Board Policy Committee Meeting and Special SMUD Board of Directors Meeting

Date: Wednesday, August 11, 2021

STAFFING SUMMARY SHEET

Chapter/Section	Page
1 INTRODUCTION	1-1
1.1 Public Review and Response to Comments	1-1
1.2 Organization of the Responses to Comments	1-2
1.3 FAA Compliance Process and Ongoing Federal Coordination	1-2

Figure 1. Suisun Marsh Protection Areas

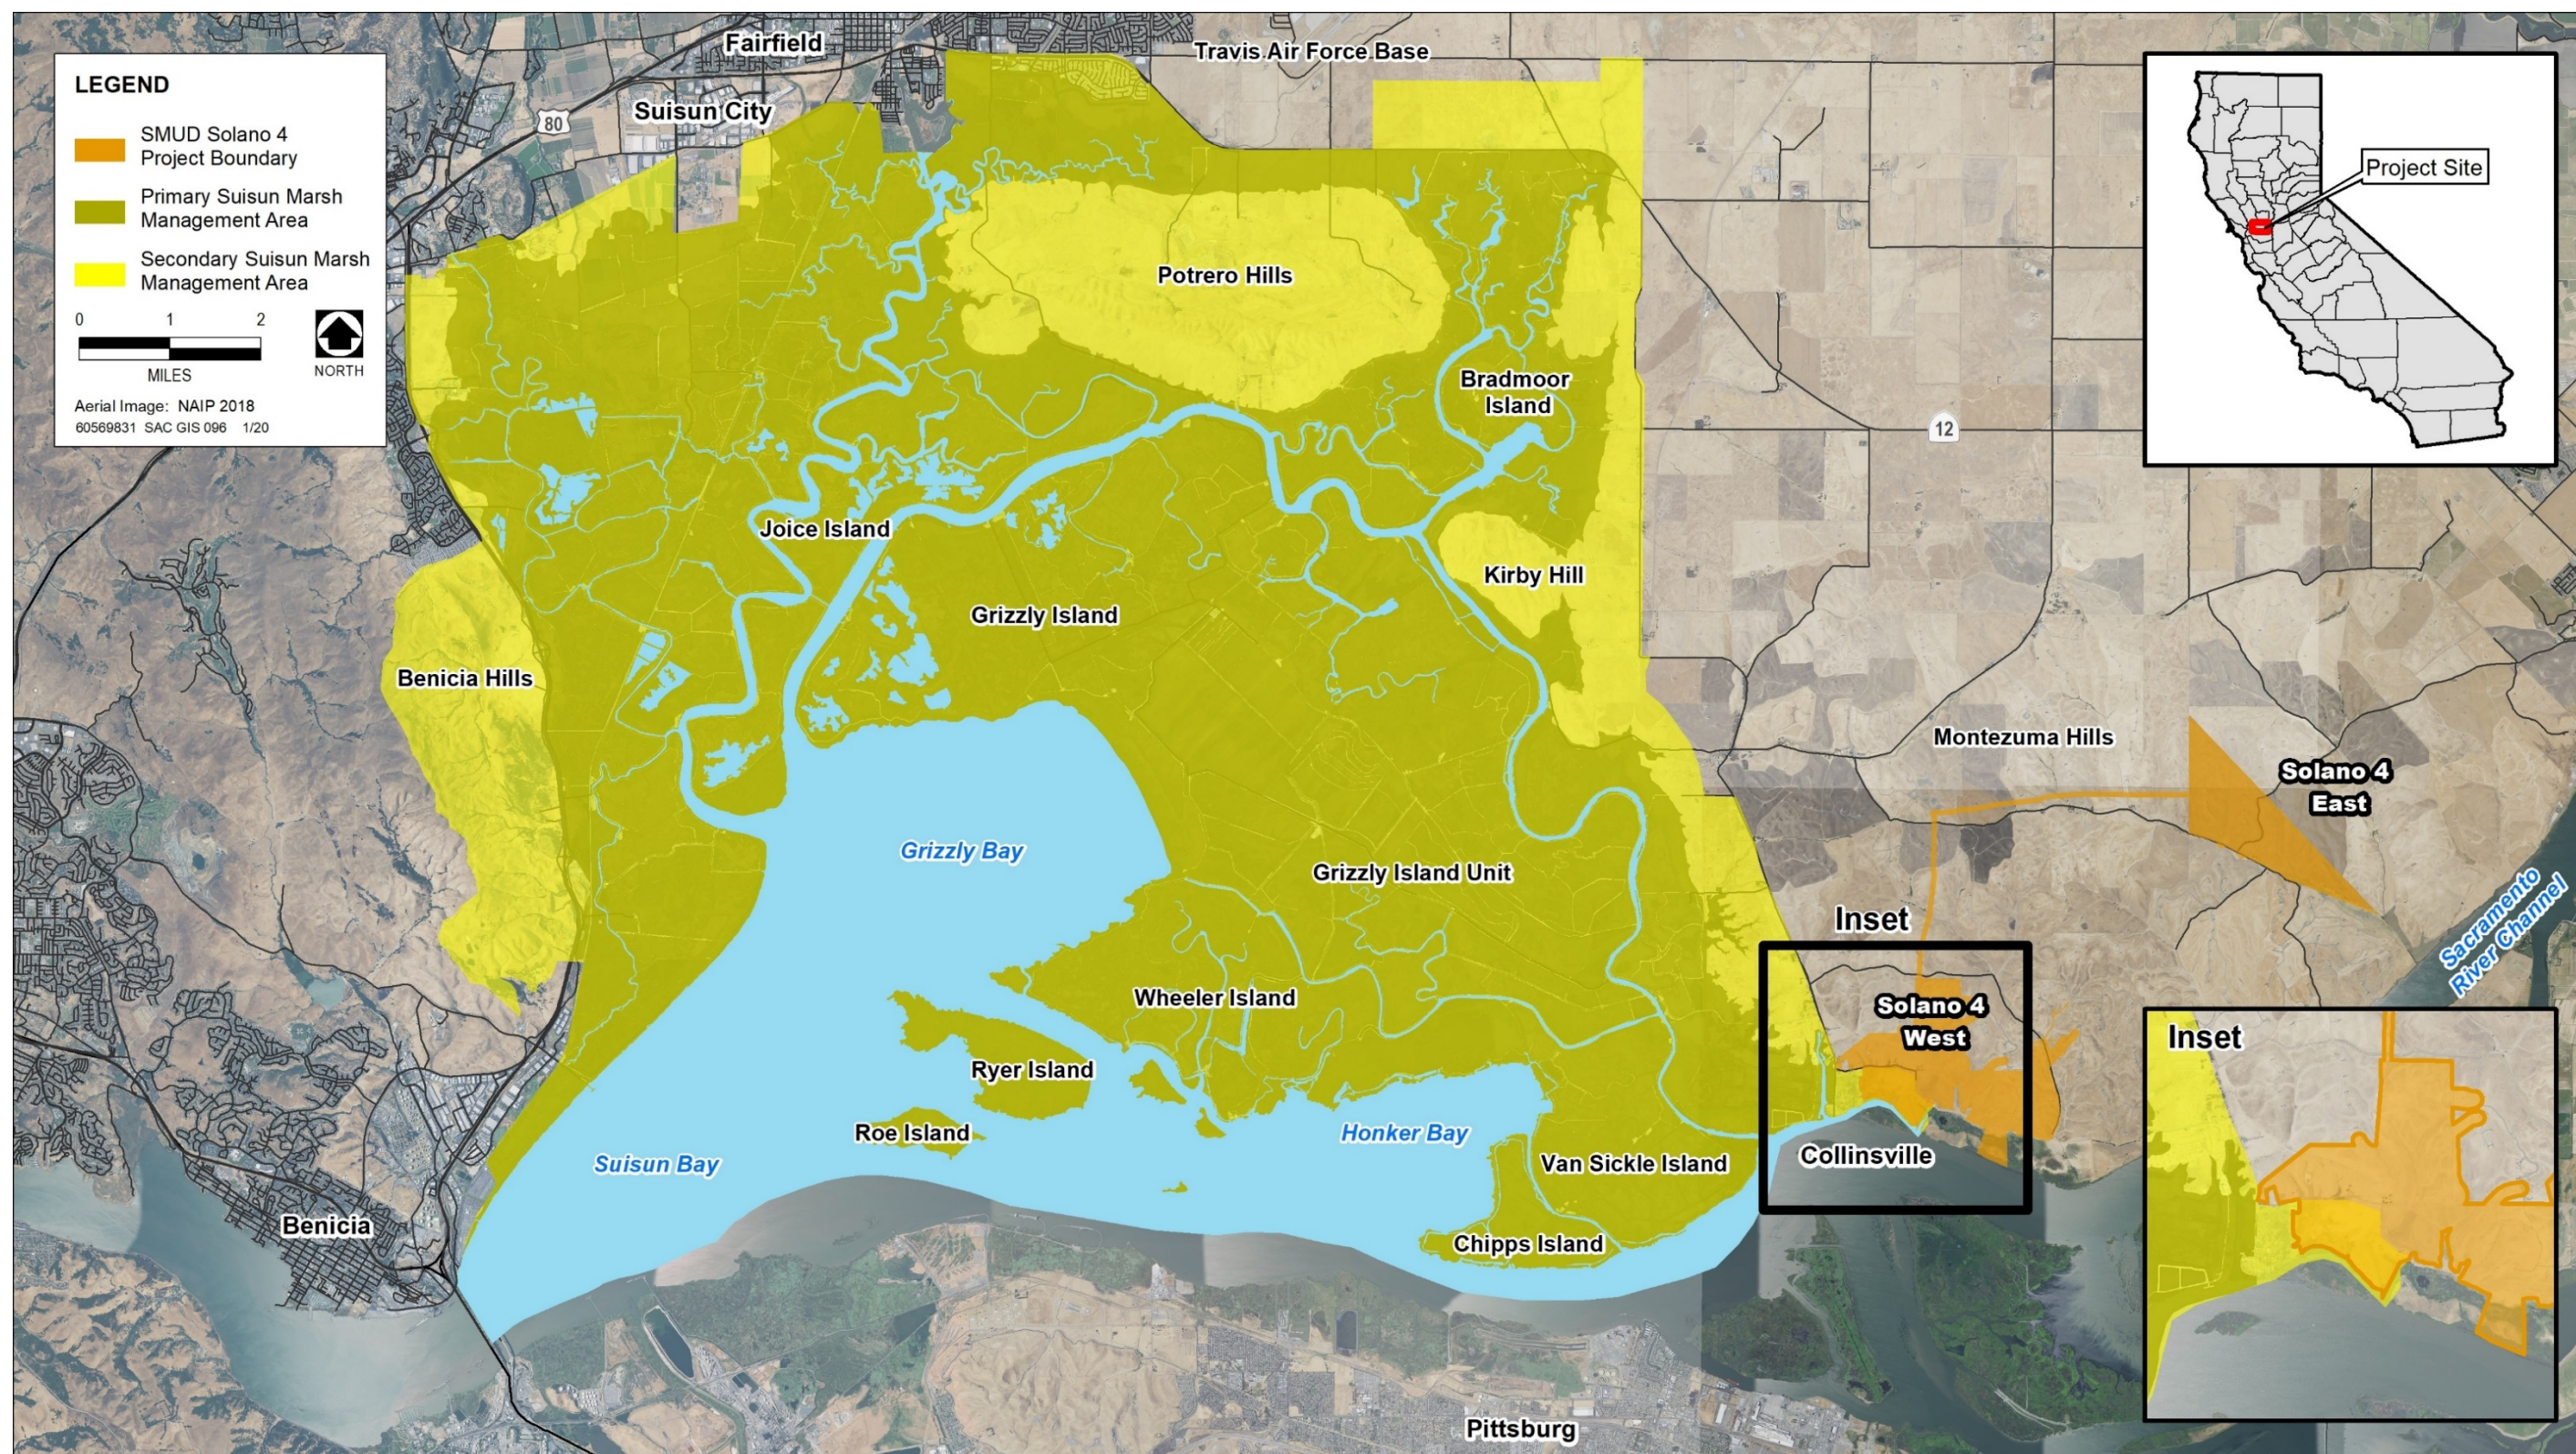
- L3-5** *Delta Plan Regulatory Policies.* *The commenter provides a description of regulatory Delta Plan policies that the commenter believes would be relevant to the proposed project if SMUD determines that the project is a covered activity. The commenter references Ecosystem Restoration Policy 3: Opportunities to Restore Habitat and cites exhibit 5-1 in Appendix 5 which shows multiple areas in the Delta recommended for prioritization and implementation of habitat restoration projects. These areas include the Suisun Marsh, which is adjacent to the project site. The commenter requests clarification as to whether any project components or temporary project elements would be located within the Suisun Marsh Priority Habitat Restoration Area (PHRA), and an assessment as to whether the project could adversely affect opportunities for restoration.*

As shown in Figure 1, the western portion of SMUD's Solano 4 Wind project area overlaps with 182.2 acres of the Secondary Suisun Marsh Management Area. This is part of the property that SMUD owns; however, no components of the proposed project (turbines, collection/home run lines, access/local roads, or staging areas) are within the Suisun Marsh PHRA and no temporary or permanent construction and operational impacts will occur within this area (see DEIR 2.5 Project Characteristics and Components, pages 2-8 through 2-27). Thus, construction and operation of the proposed project will not affect ongoing and future planned restoration activities in the Suisun Marsh. No revisions to the DEIR are necessary.
